NASA SUSPENDED LOAD OPERATION INTERIM ANALYSIS/APPROVAL

Installation of the ACTS Apogee Kick Motor

2. REQUESTOR R. T. Gedney	ORGN. NASA/LeRC	PHONE (216)433-3552	DATE June 26, 1992	REQUEST NO. SLO-KSC-1992-001
3. CONTRACTOR	4. CONTRACT NO.	5. VEHICLE/GSE/EFFECTIVITY FACILITY Advanced Communications Technology Satellite		6. TIME PERIOD/DURATION One-Time Only
7. DOCUMENT GE Procedure TP-AKI-2623352	8. TITLE AKM Installation			9. ITEM NO. Section 6.2

ACTS Launch Site Hoisting & Handling AKM Installation

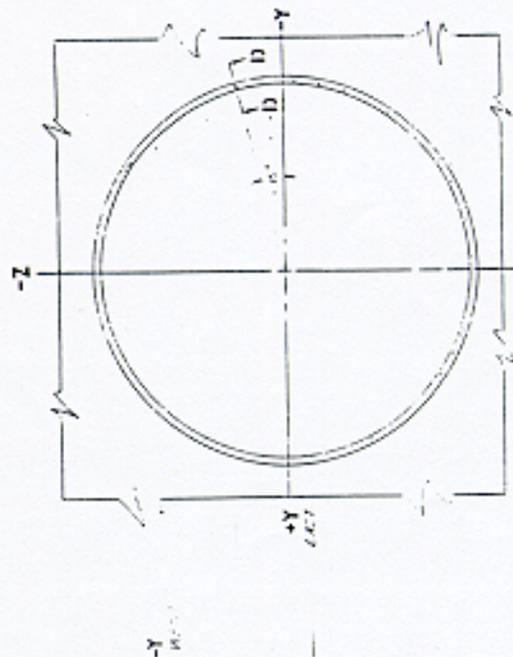
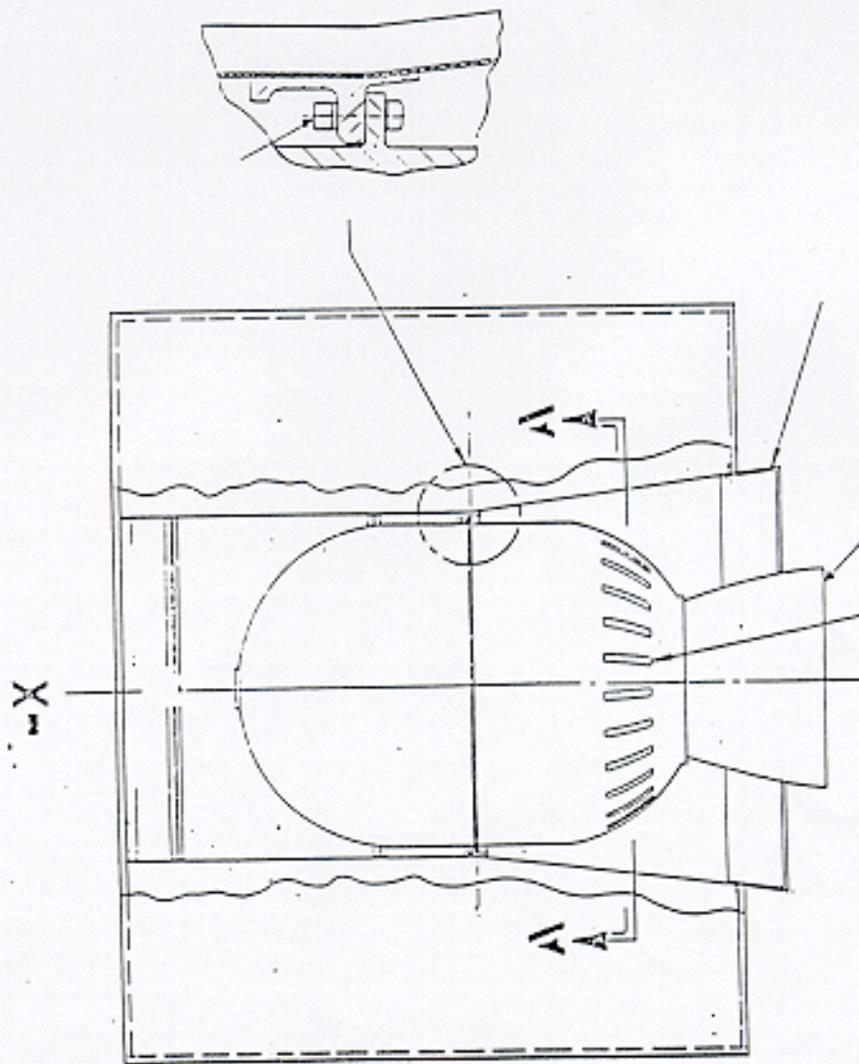
The ACTS Apogee Kick Motor (AKM) is installed inside the central cylinder of the spacecraft (refer to attachment #1). The spacecraft central cylinder has a mounting flange that mates with the mounting flange on the AKM and accepts 48 bolts. The AKM is installed by lowering the spacecraft over the AKM as it rests on an installation stand (refer to attachment #2). Because the clearance between the spacecraft flange and the AKM is very small (on the order of 35 mils), personnel are required to get under the load to take measurements verifying that the spacecraft is well centered over the AKM. Without these measurements, the spacecraft could damage the AKM during the installation process by contacting the AKM case, heat shields, or heaters. Additionally, there are four small diameter aluminum alignment rods that are installed to the spacecraft flange prior to hoisting the spacecraft off of its dolly. These rods mate with holes in the AKM flange and provide coarse alignment to help guide the spacecraft onto the AKM. Personnel are required under the load to initially thread these rods into the AKM flange.

When the two flanges are nearly mated a technician must go under the load to verify that the alignment of the AKM index pin is correct. This is required to ensure that the two bolt patterns are properly clocked. This task is not of concern because the spacecraft and AKM flanges are approximately one inch apart. If the load were dropped, it would come safely to rest on the AKM flange (which is in turn supported by the installation stand).

ATTACHMENT #3

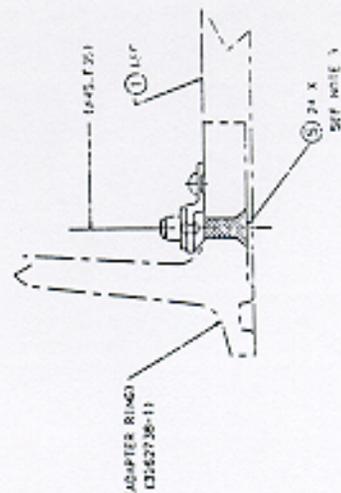
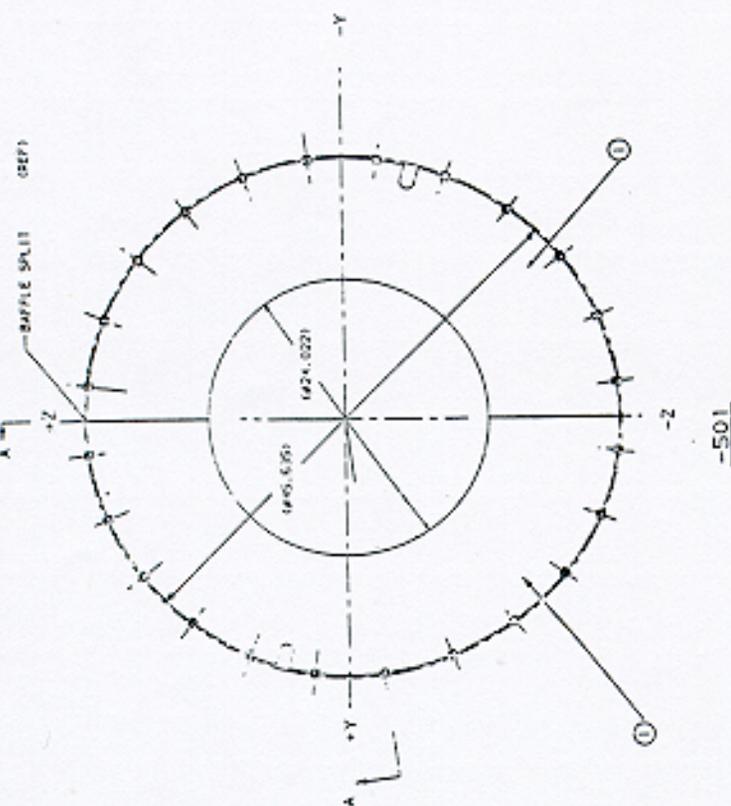
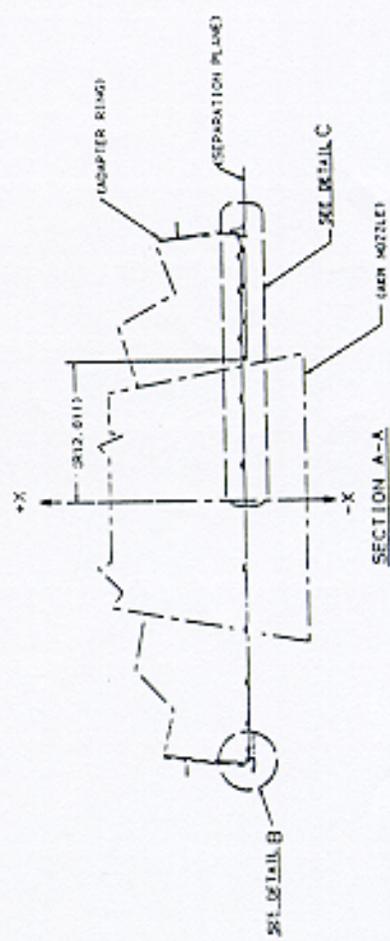
The final task involving exposure to the suspended load is installation of the AKM thermal baffle. This is done after the spacecraft, with AKM mated, is hoisted off the installation stand. The baffle attaches to the spacecraft adapter ring as shown in attachment #3 using 24 fasteners. Because of clearances required to install these fasteners, the baffle cannot be installed while mated to the Perigee Stage Adapter (PSA), dolly, or installation stand.

ATTACHMENT #4

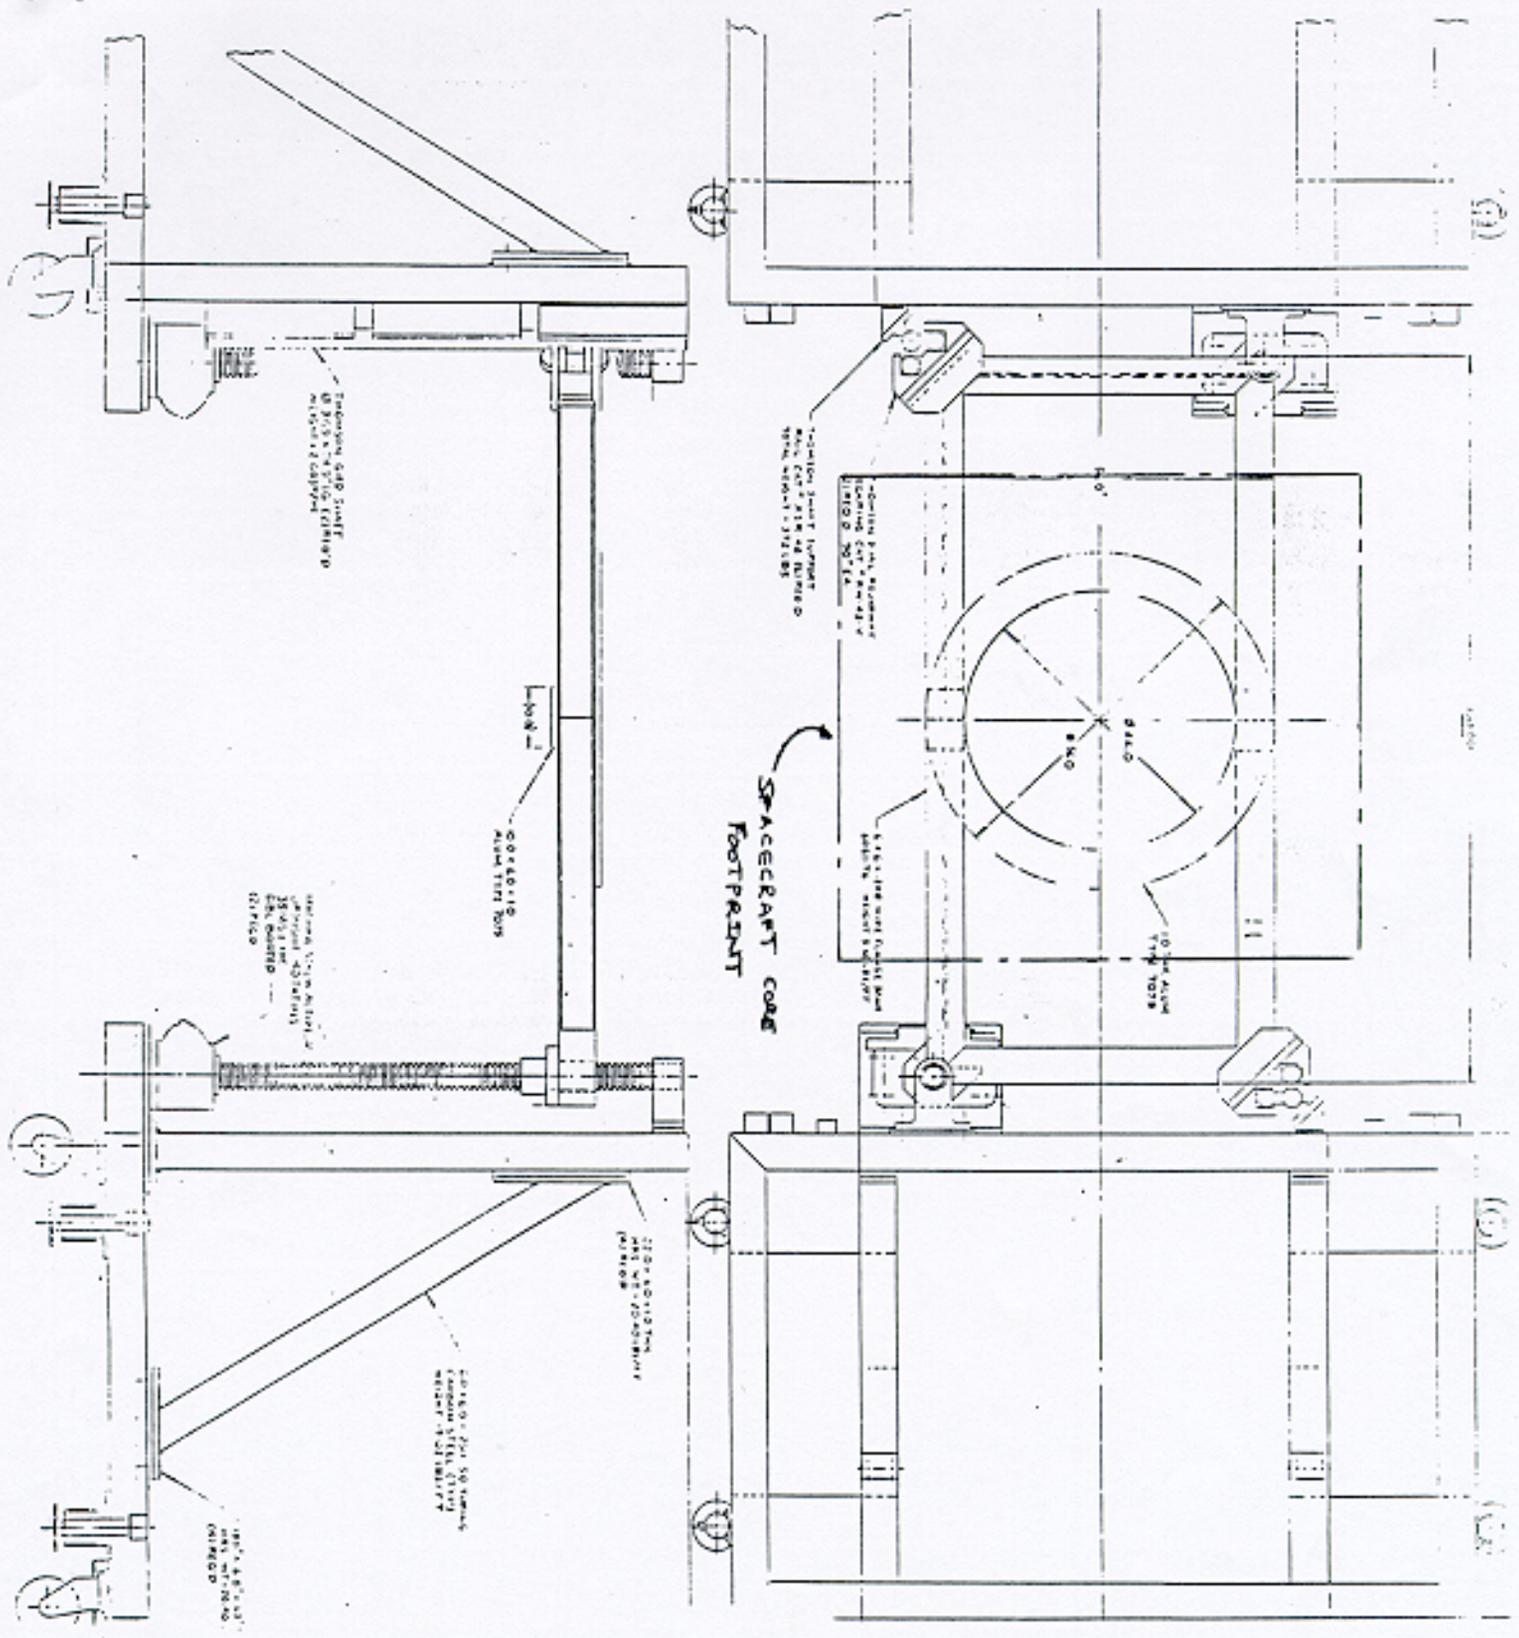
The measurement operations never take place while the load is moving. Personnel only move under the load when it is static and steady. A secondary support system has been thoroughly evaluated (refer to attachment #4). The secondary support consists of a movable platform with a flat ring to catch the spacecraft at the separation ring should it drop. This platform is moved using two hand-operated jack screws as the spacecraft is lowered. The spacecraft must remain unconstrained during the installation operation to prevent binding on the AKM. The platform is therefore lowered gradually with the spacecraft so that a small gap is always present. The gap is not allowed to exceed 2 inches to limit the dynamic force that the support structure would have to handle should the spacecraft fall.

However, examination of attachment #4 shows the limited access for ingress to, and egress from, the work area. On the East and West sides of the spacecraft, technicians would be forced to crawl through an 11-inch space between the support structure and the AKM installation stand to access the work area. On the North and South sides of the spacecraft, technicians would have to maneuver around the solar array and the platform support beam 27 inches off the floor. In the event of an emergency requiring a quick exit from the work area, the exit paths are extremely limited. Many alternative configurations for this structure were studied but none were able to provide adequate access for quick egress. This lack of quick egress is the principal reason for ruling out the use of a secondary support structure.
